100 Park Street Winnsboro, TX 75494 903.342.5523	THIS DRAWING INTENDED FOR REVIEW / AUTHORIZATION PURPOSES ONLY AND MAY NOT BE DISCLOSED, REPRODUCED OR USED WITHOUT THE EXPRESS WRITTEN PERMISSION OF USA HARNESS, INC.		STAMP:	DATE:	QTY:	CONTROL:		
REV	PROJ#	CHANGE			DATE	BY	Customer: BIG TEX TRAILERS			ISSUE:
00	4199	INITIAL PRODUCTION RELEASE (WAS BTX-280_C AND BTX-281_B)			04/02/14	BM	Description: NOSE END, 7 WAY RV PLUG, 7 POLE, GNECK			
							Eng. app:	Part#:	Rev.:	
								BTX-9900286	00

Quality ALERT!

TAKESTOCK 6550058 BREAKAWAY KIT ICU WITH CHARGER & SWITCH

GN ALTERNATIVE WIRING W/ STD BRK-A-WAY KIT

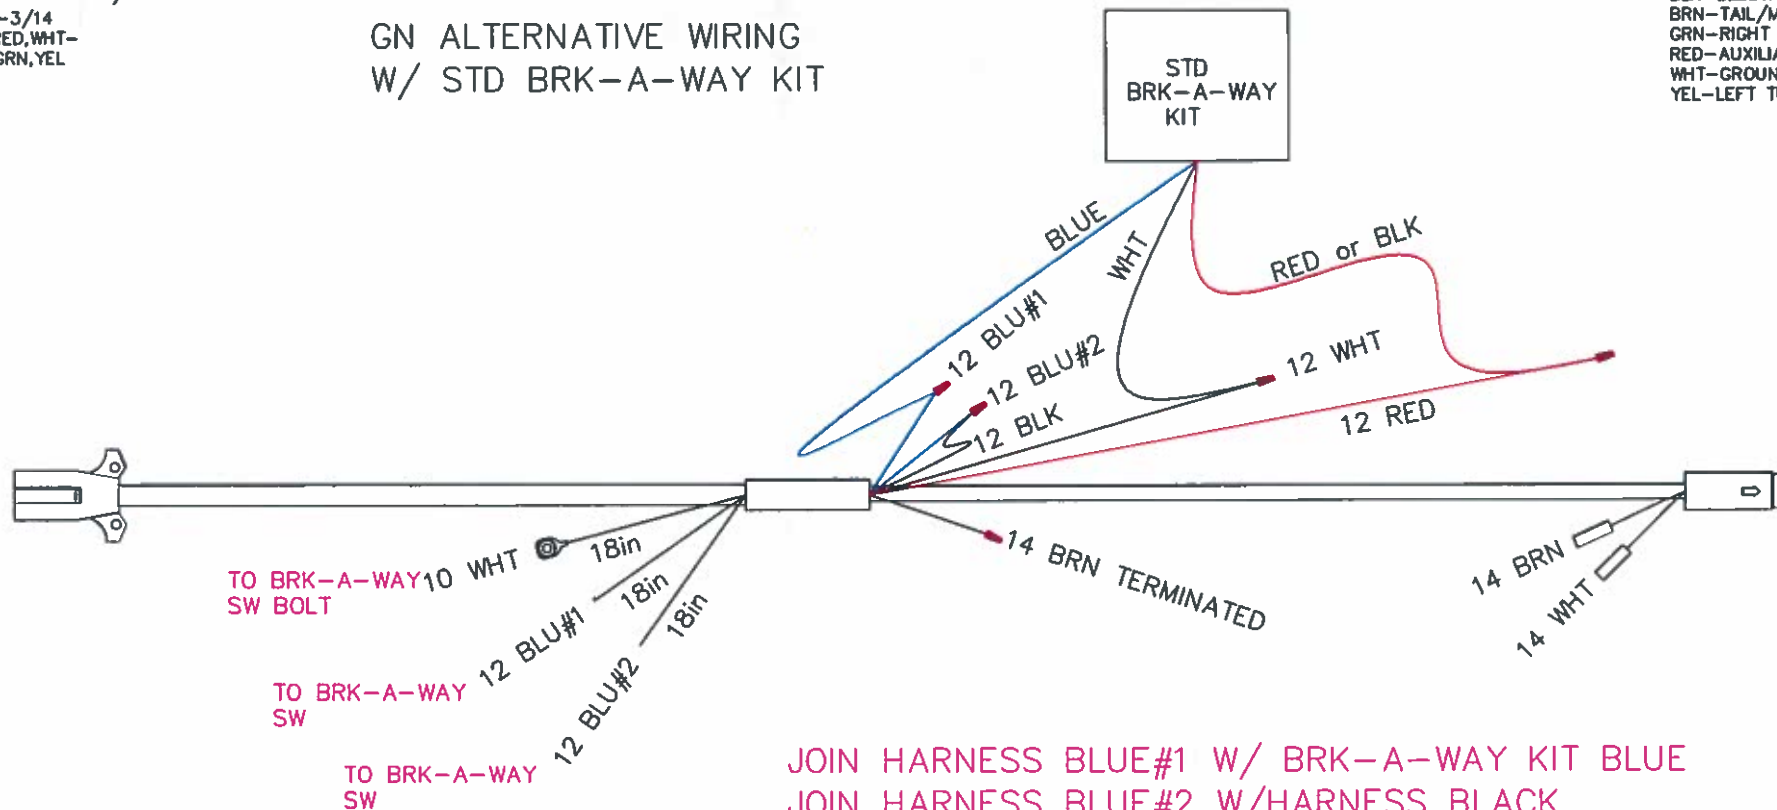
When the breakaway is pulled, the ICU diode overheats, ICU failure.

JOIN HARNESS BLUE#1 W/ BRK-A-WAY KIT BLUE
JOIN HARNESS BLUE#2 W/HARNESS BLACK
JOIN HARNESS RED W/BRK-A-WAY KIT RED OR BLACK
JOIN HARNESS WHITE W/ BRK-A-WAY KIT WHITE

In production, continue to install, following alternate wiring instructions provided in the .pdf's, until replacement part TakeStock 6550020 (Break-A-Way Kit W/Charger 5 AMP Hour) has been received. The replacement part does NOT include an ICU flasher component.

When TakeStock 6550020 has been received, collect TakeStock 6550057 and 6550058 for return to Brightway.
